## Firmware 2.06.3 bug list:

## List of bugs/improvement requests

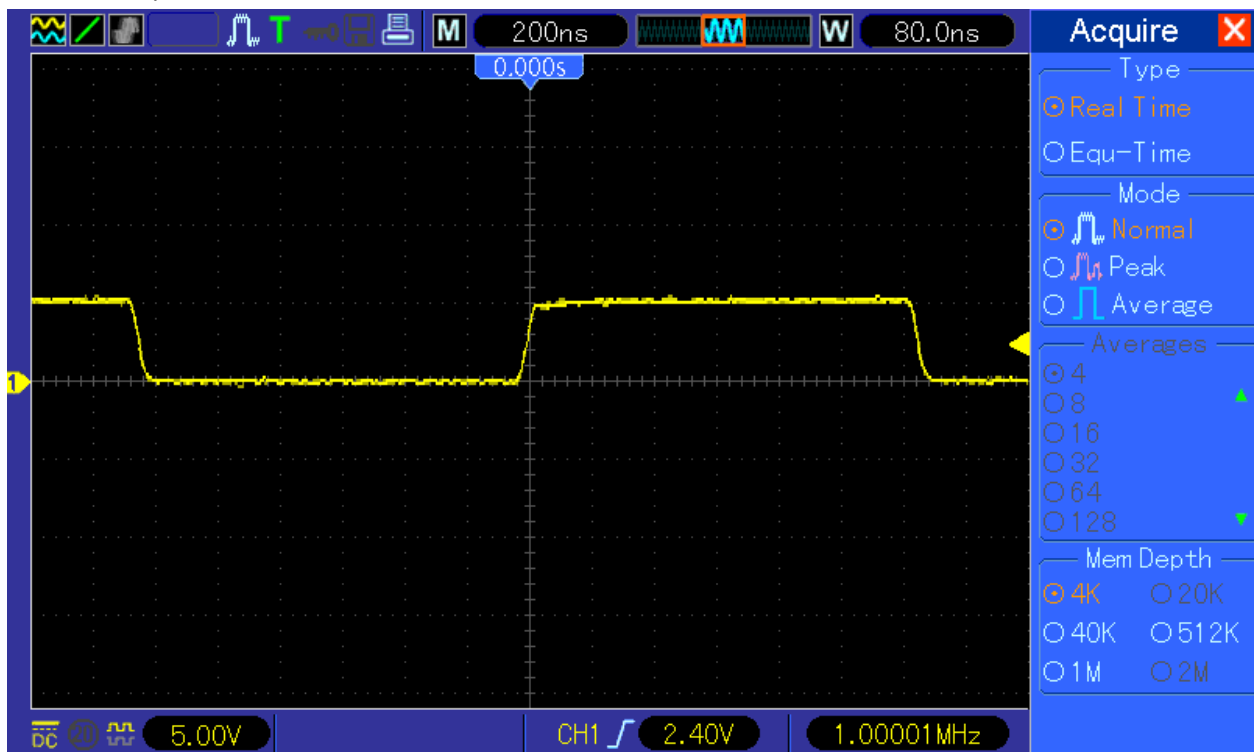
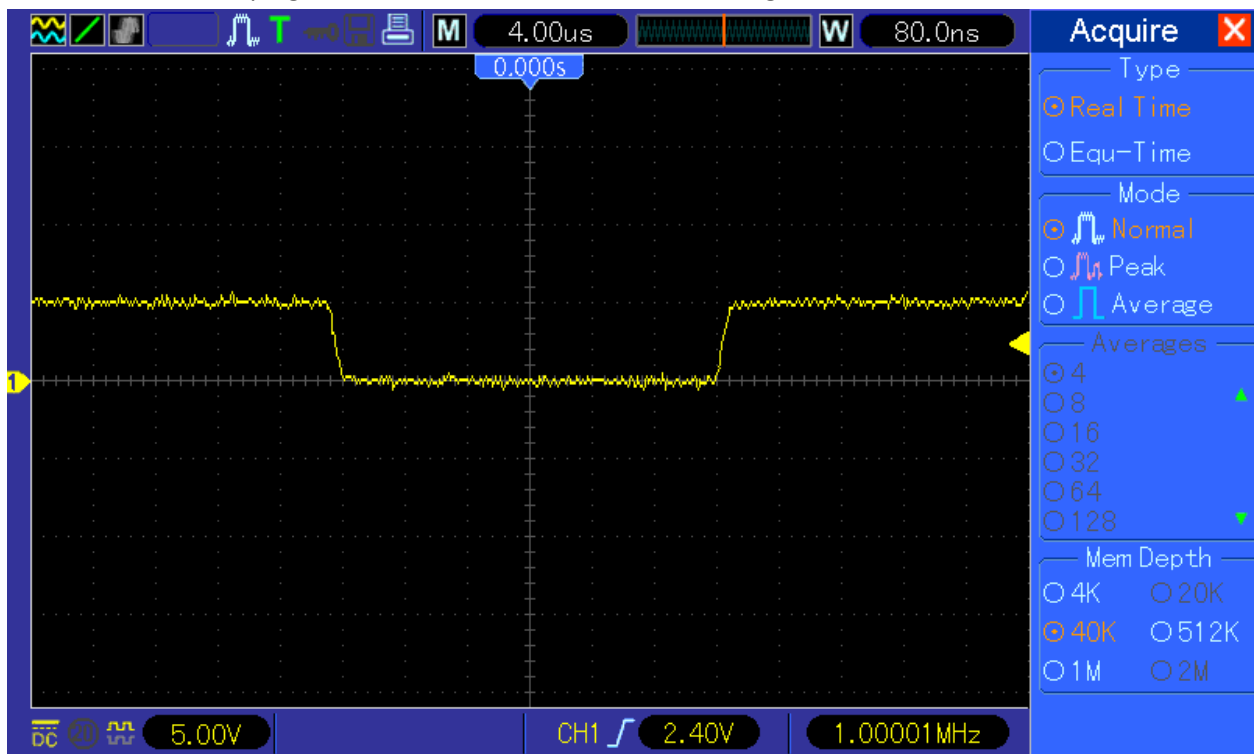
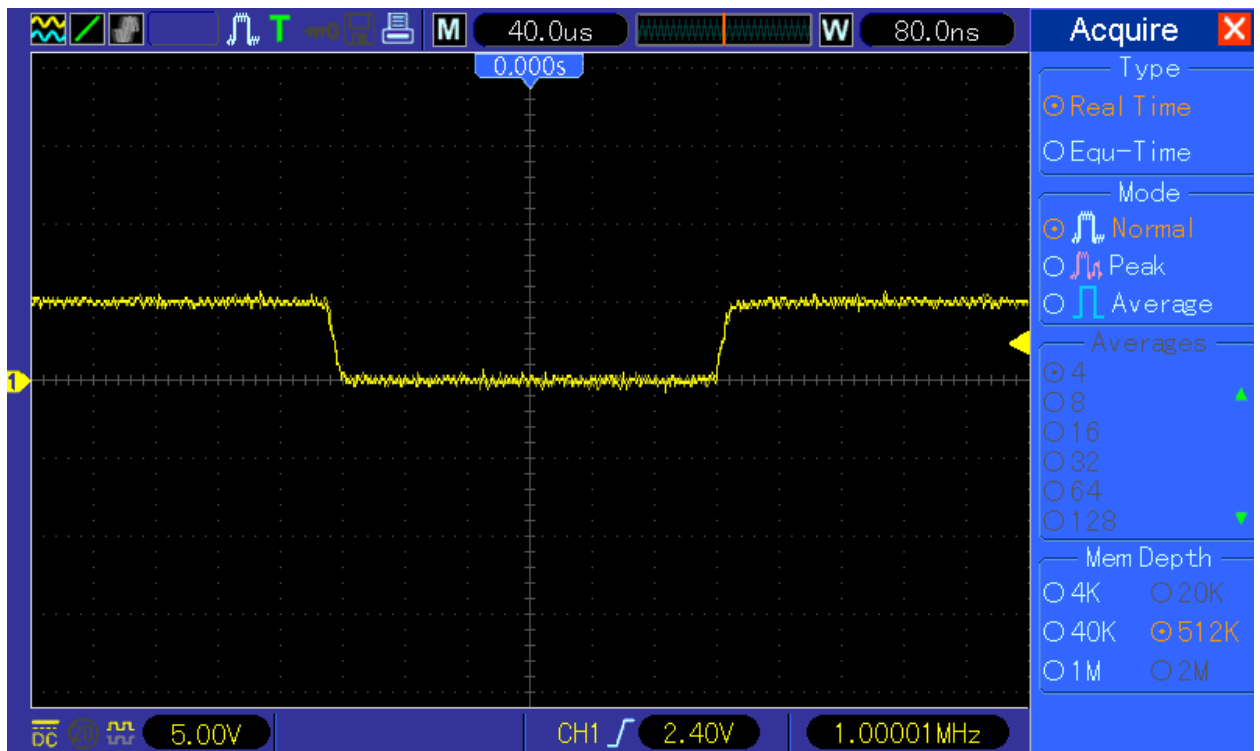
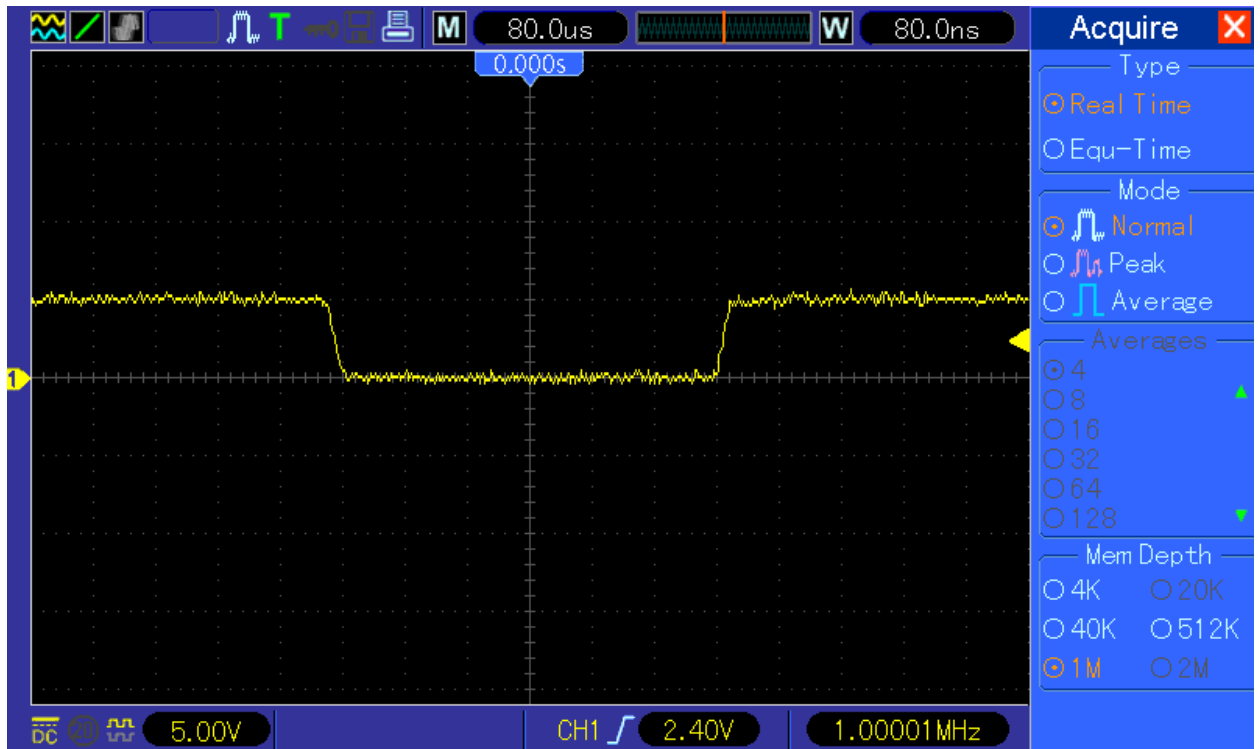
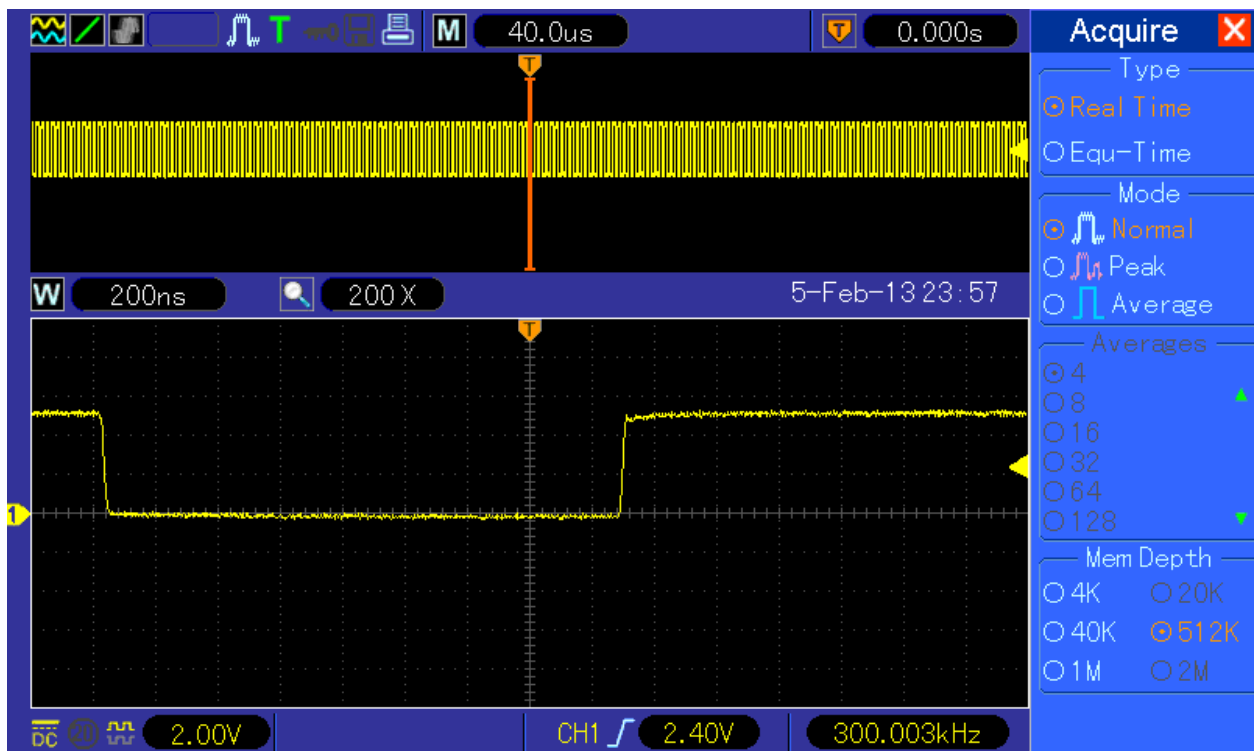
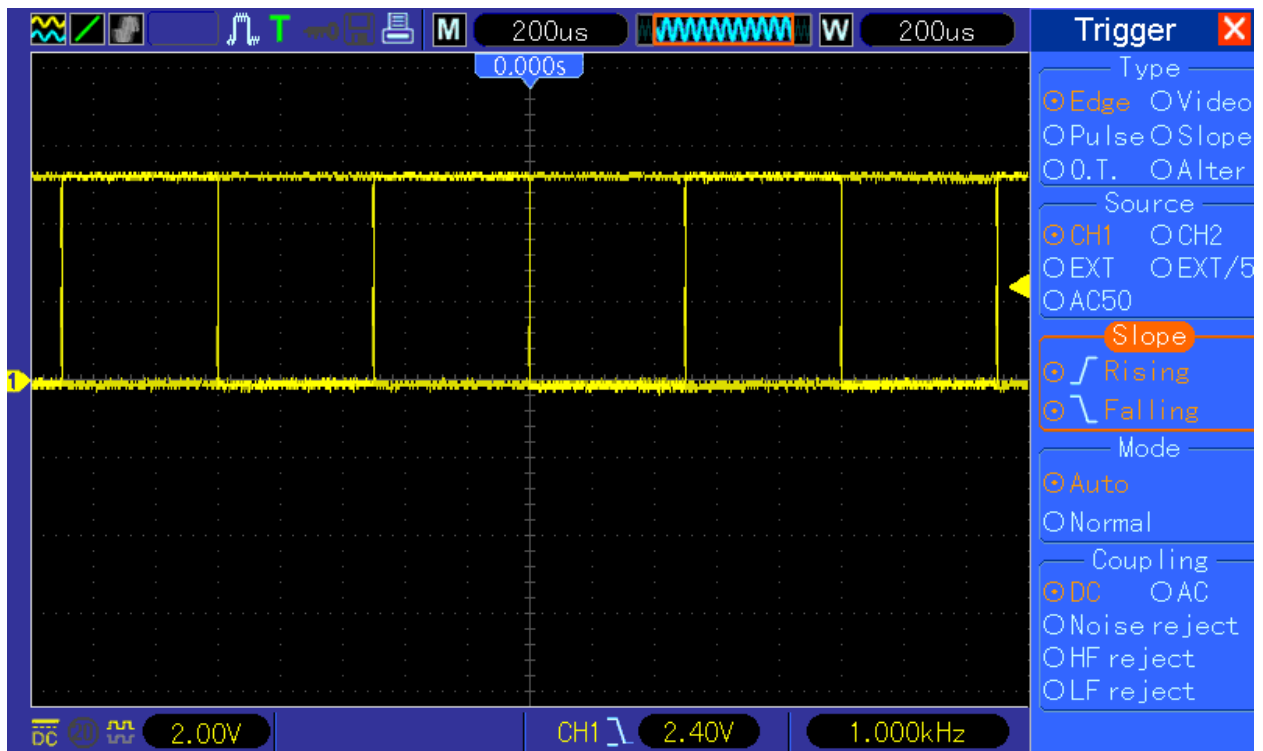
51. Trigger position broken in 40k, 512k and 1M memory depth mode.

Set DSO to 4k, 80ns/DIV, ch1 enabled, apply 1MHz square, the trigger is in the middle of the screen as expected:

Switch now to 40k, trigger is moved, zeroing of trigger position, selfcalibartion and even factory calibration is not helping. Tested with 83E9 and 83EB FPGA designs:

same problem in 512k:

and in 1M:

in dual window same problem in 40k/512k and 1M memory depth:

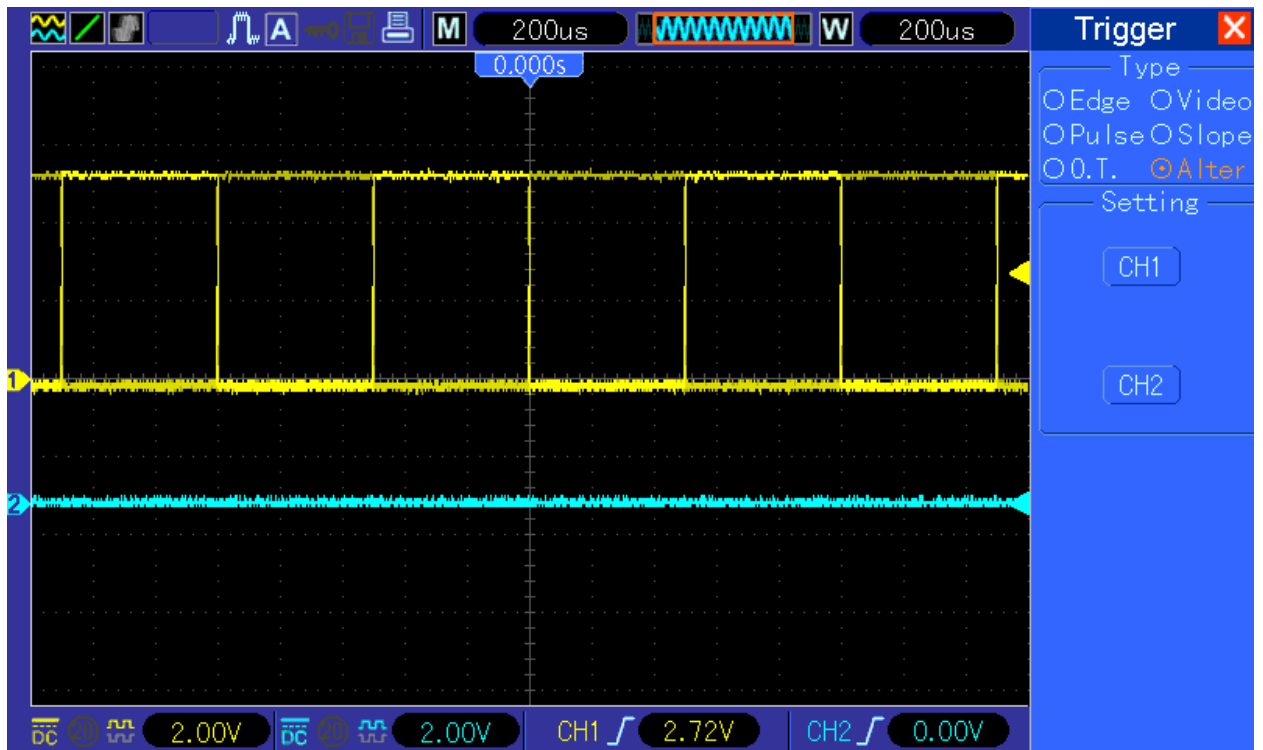
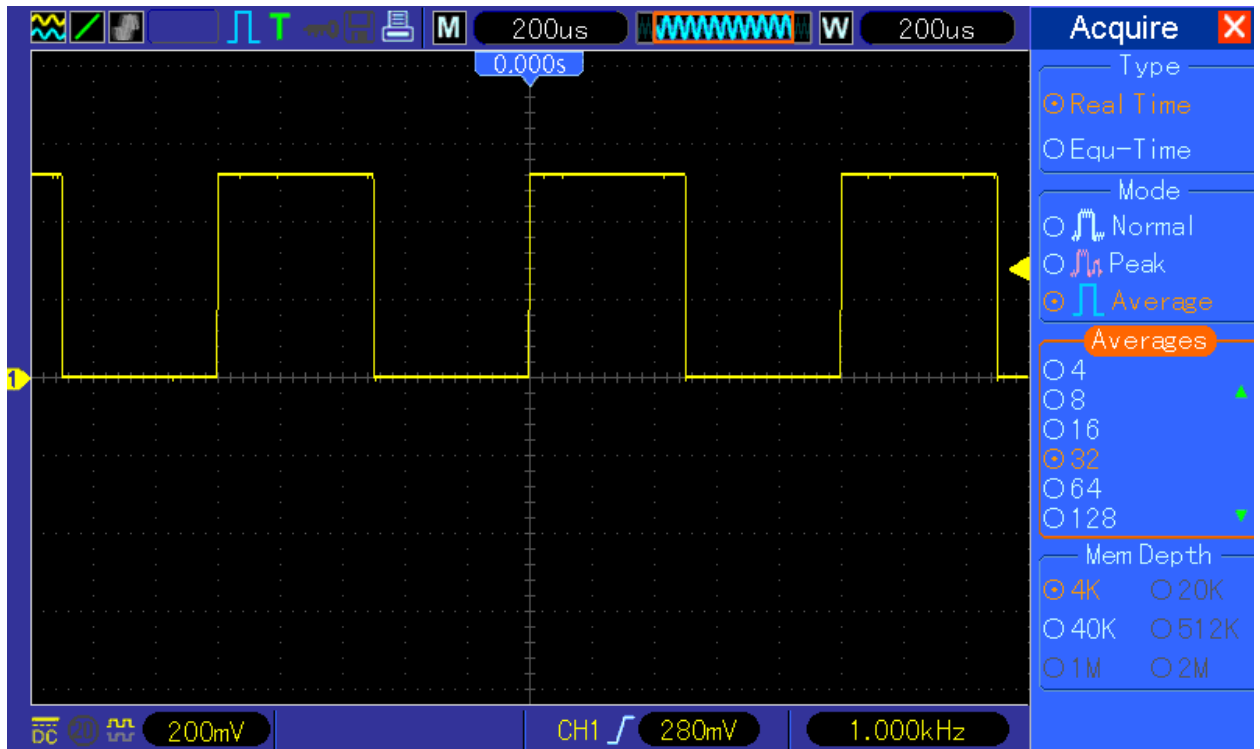
52. After enabling the Dual Slope in Edge trigger:

and changing to Alternate Trigger mode, the Dual Slope seems to be still on:

but I assume should be off? (I'm not sure about the intention here).

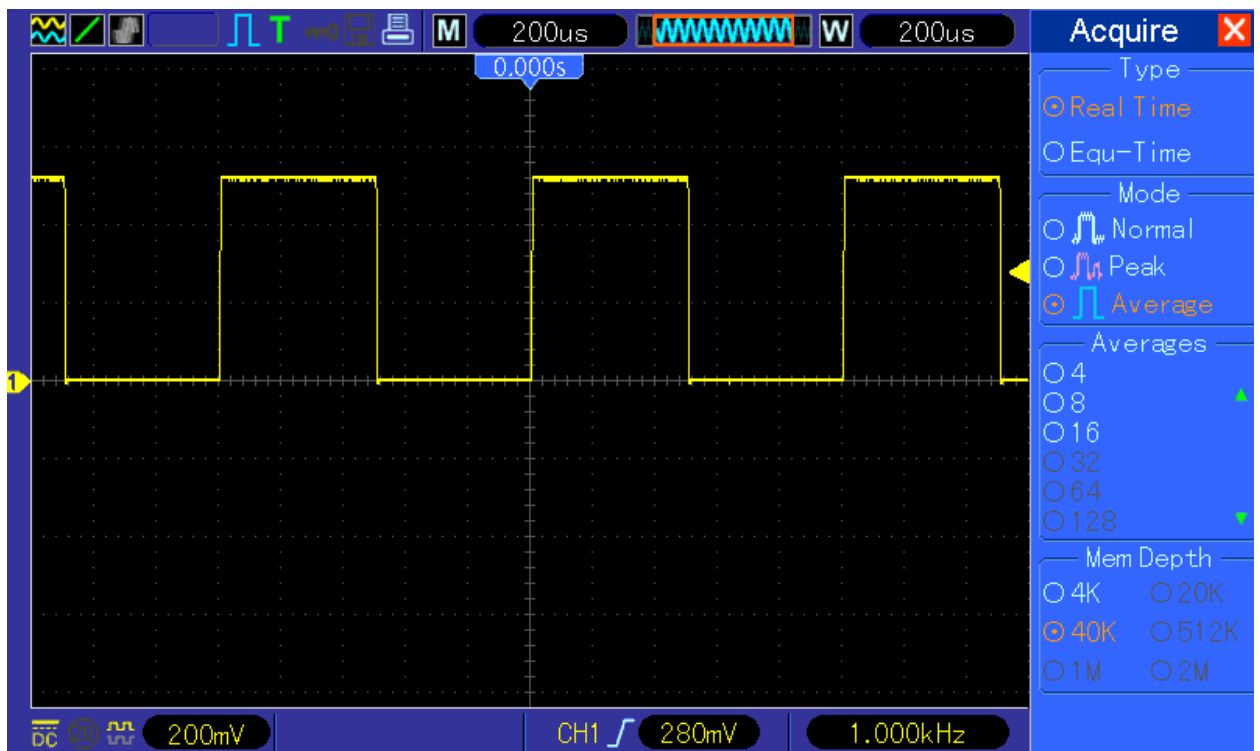
53. When number of Averages is higher than 16, and changing from 4k memory depth:

to 40k memory depth, the number of averages is showing nothing:
